UNITED STATES
DEPARTMENT OF THE INTERIOR
BUREAU OF LAND MANAGEMENT

FORM APPROVED
OMB NO. 1004-0137
Expires: January 31, 2018**SUNDRY NOTICES AND REPORTS ON WELLS**
*Do not use this form for proposals to drill or to re-enter an abandoned well. Use form 3160-3 (APD) for such proposals.*5. Lease Serial No.
NMLC063228

8. Well Name and No.
TRISTE DRAW 25 FEDERAL COM 12H

Cimarex respectfully request approval for a multibowl well head, please see attached diagram and procedure.

Cactus Multi-Bowl Wellhead Steps:

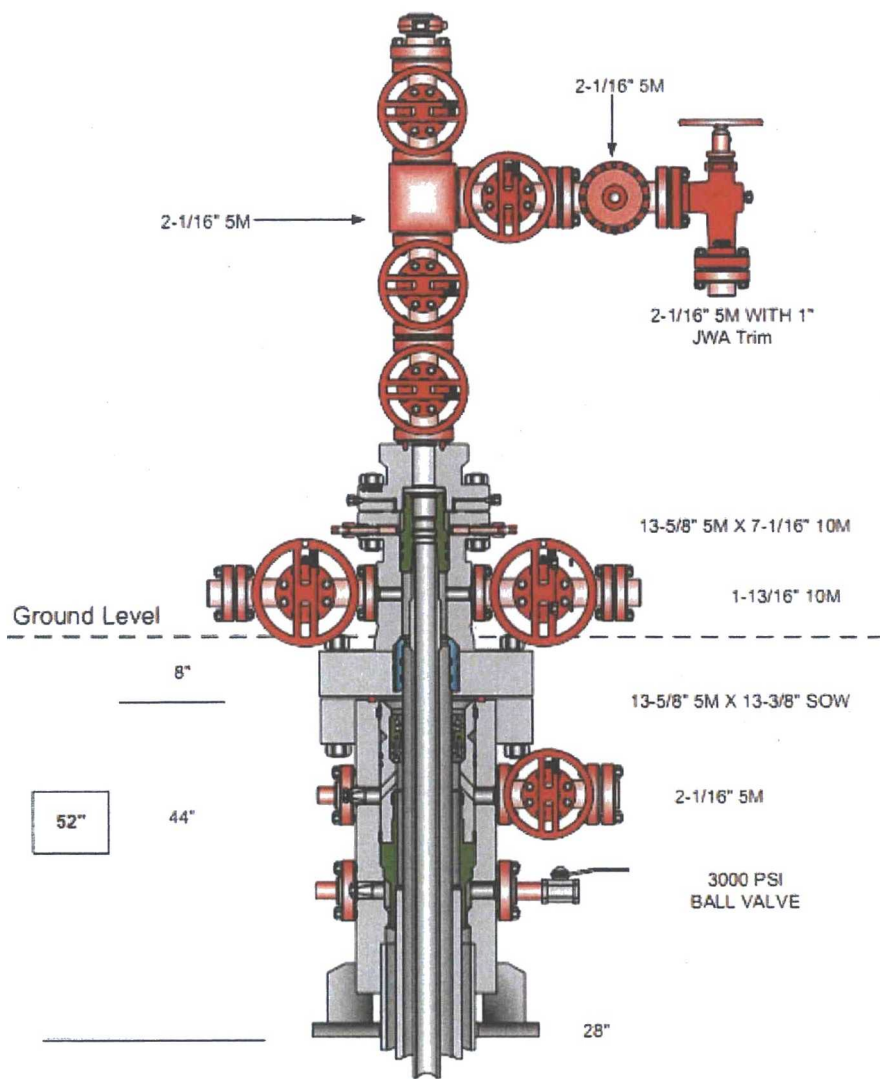
** BLM REVISED ** BLM REVISED ** BLM REVISED ** BLM REVISED ** BLM REVISED **

Note: We will not Test BOP's after welding on the Surface head unless we exceed the 30 day limit per Onshore Order #2.

If the operator has proposed a multi-bowl wellhead assembly in the APD. The following requirements must be met:

- a. Wellhead shall be installed by manufacturer's representatives, submit documentation with subsequent sundry.
- b. If the welding is performed by a third party, the manufacturer's representative shall monitor the temperature to verify that it does not exceed the maximum temperature of the seal.
- c. Manufacturer representative shall install the test plug for the initial BOP test.
- d. If the cement does not circulate and one inch operations would have been possible with a standard wellhead, the well head shall be cut off, cementing operations performed and another wellhead installed.
- e. Whenever any seal subject to test pressure is broken, all the tests in OOGO2.III.A.2.i must be followed.
